PROJECT *(Name and Address)*
EAST HEIGHTS ELEMENTARY SCHOOL RENOVATION
1776 ADAMS LANE
HENDERSON, KY 42420

CHANGE ORDER NUMBER: 14-1-1
INITIATION DATE: 6/11/2025

Re: PR-01– Electrical Panelboards
Henderson Co. East Heights Elementary School
CMTA Project No. XHER23

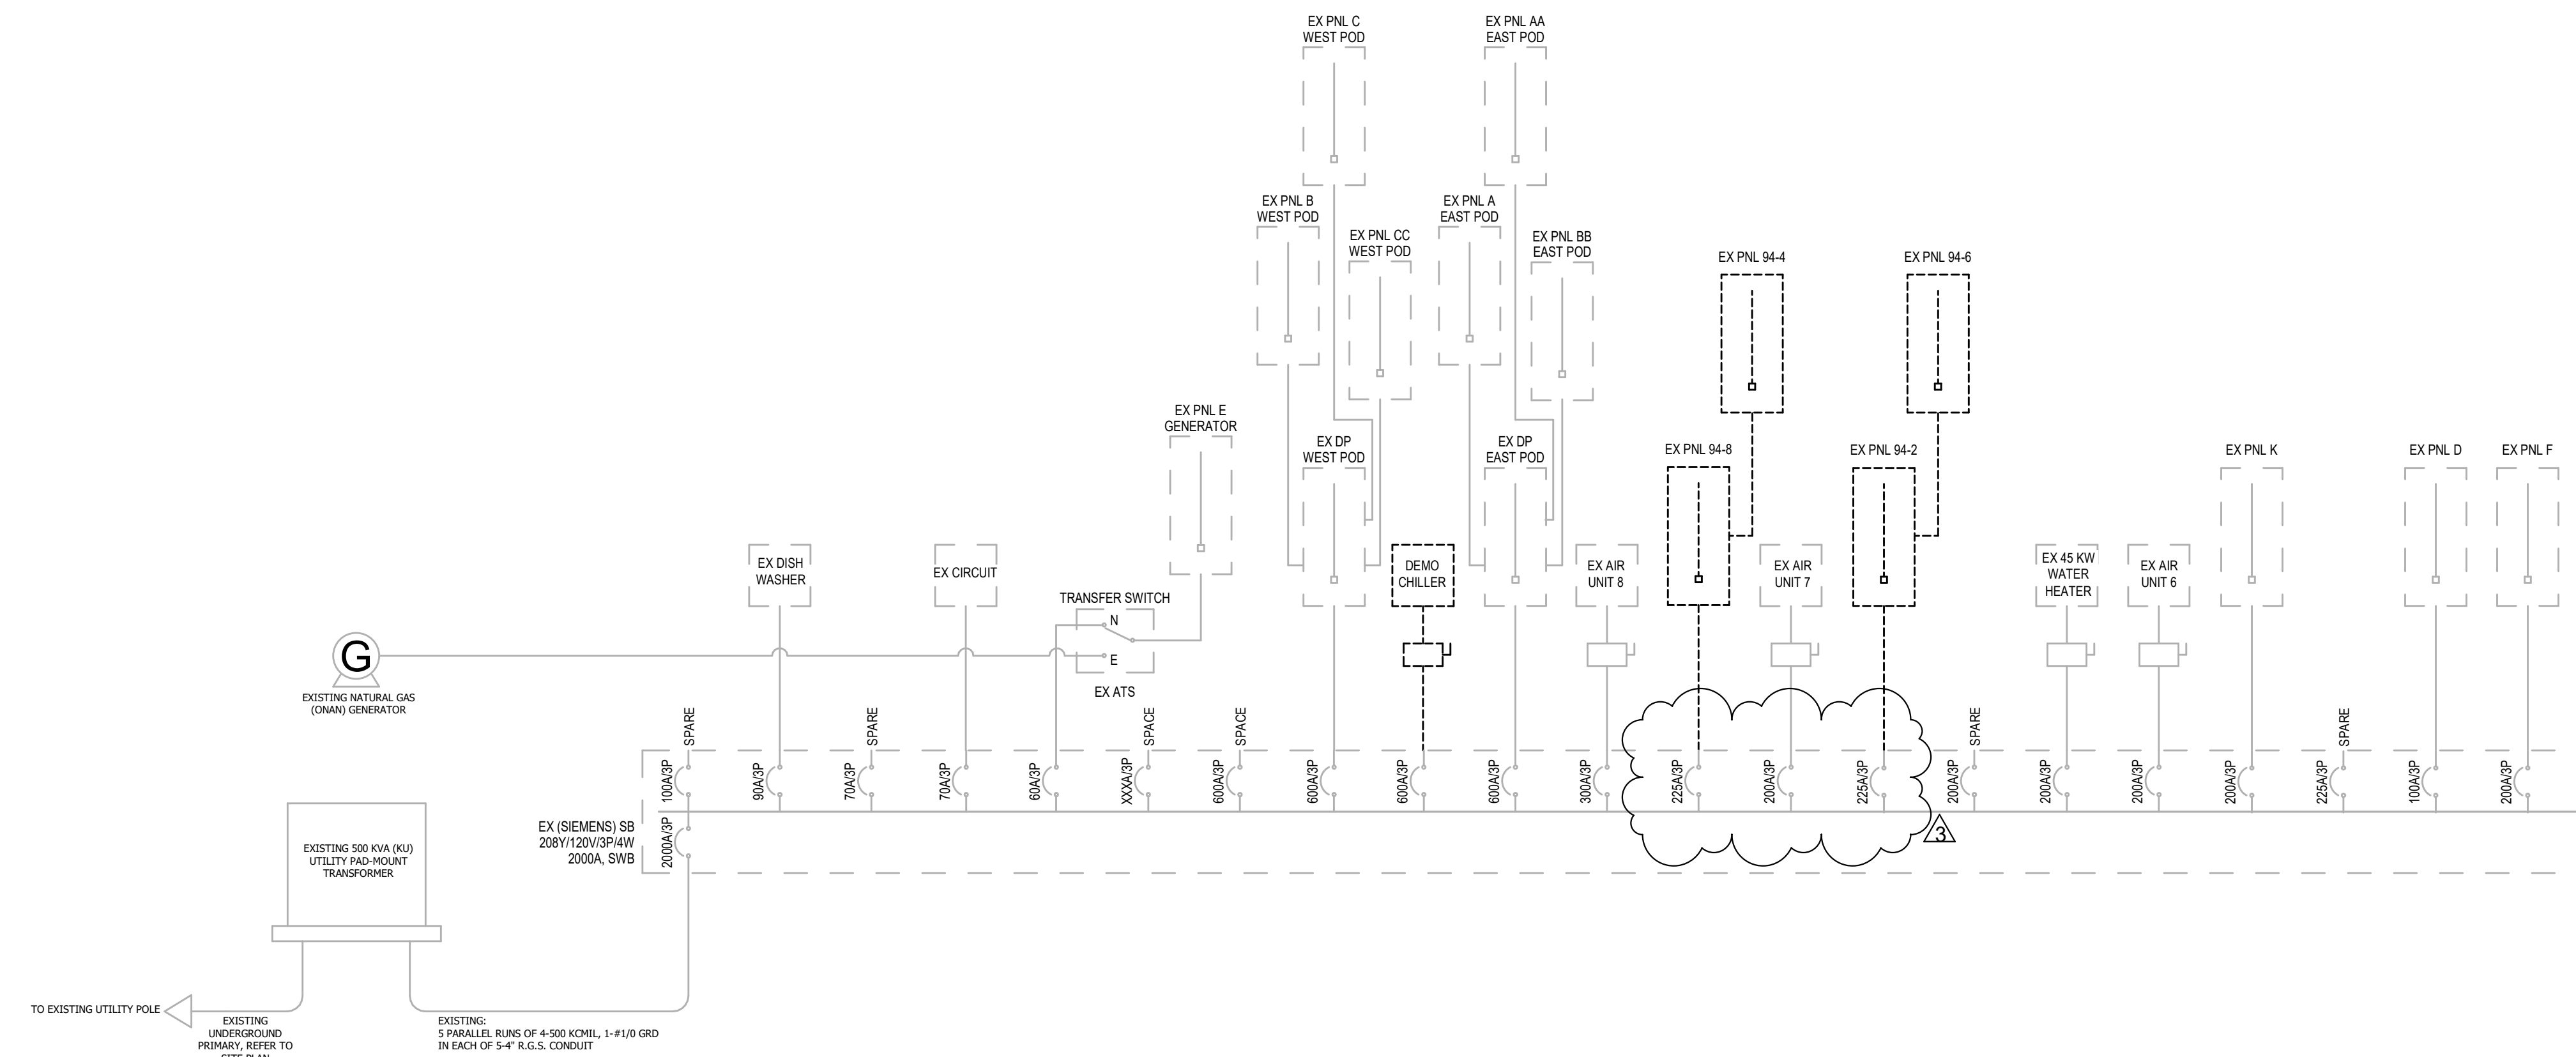
1. Refer to Sheet E0.30 – PANEL SCHEDULES:
 - a. Refer to clouded region. Provide 225A panel for PP3 instead of 100A.
 - b. Refer to clouded region. Provide 60A/3P breaker at PP3 panel for LP3 instead of 100A/3P breaker. Refer to clouded changes on One-line diagram for updated wire size and conduit: 4-#6, 1-#10 instead of 4-#3, 1-#8.

- c. Refer to clouded region. PP5 panel shall be MLO instead of MCB.
2. Refer to Sheet E0.31 – PANEL SCHEDULES:
 - a. Refer to clouded region. MP1 panel shall be MLO instead of MCB.

- b. Refer to clouded region. DP4 distribution panel shall be MLO instead of MCB.
 - c. Refer to clouded region. ELS1 panel shall be 225A MCB instead of 100A MLO. Provide 60A/3P breaker at ELS1 panel for ELS1B instead of 100A/3P breaker. Refer to general note shown on this panel schedule. Refer to clouded changes on One-line diagram for updated wire size and conduit.

- d. Refer to clouded region. ESB1 panel shall be 225A MCB instead of 225A MLO. Refer to general note shown on this panel schedule.
 - i. Refer to One-line diagram and clouded region on Sheet E3.78: Omit SBATS2 transfer switch to panel ESB2. ESB2 panel shall be fed from ESB1 panel and be provided with 60A/3P breaker at ESB1. Refer to One-line diagram for wire size and conduit.

1. ESB2 panel shall be 100A MLO instead of 225A MCB.
 - ii. Refer to One-line diagram: Refer to updated wire size and conduit for panel ESB1B.
3. Refer to Sheet E2.78 – ELECTRICAL ONE-LINE DIAGRAM DEMOLITION – PHASE 2
